**FINAL PRODUCT/PROCESS CHANGE NOTIFICATION #16791**Generic Copy

**Issue Date:** 22-Mar-2012**TITLE:** ON Semiconductor Seremban added as a second manufacturing Site for CAT6243**PROPOSED FIRST SHIP DATE:** 22-Jun-2012 or earlier upon customer's approval**AFFECTED CHANGE CATEGORY(S):** CAT6243**FOR ANY QUESTIONS CONCERNING THIS NOTIFICATION:**Contact your local ON Semiconductor Sales Office or Thruston Awalt <[thruston.awalt@onsemi.com](mailto:thruston.awalt@onsemi.com)>**SAMPLES:** Contact your local ON Semiconductor Sales Office**ADDITIONAL RELIABILITY DATA:** Not applicable**NOTIFICATION TYPE:**

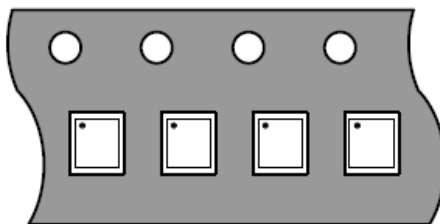
**Old orientation:**

Pin 1 (Upper Left)

**New orientation:**

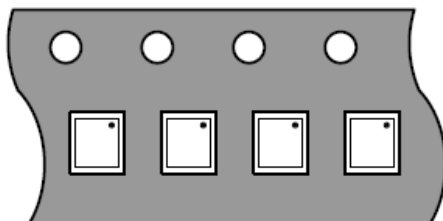
**CHANGED PART ORIENTATION – Tape and Reel packaging:** Applies to all assembly sites used.

Pin 1 (Upper Right)
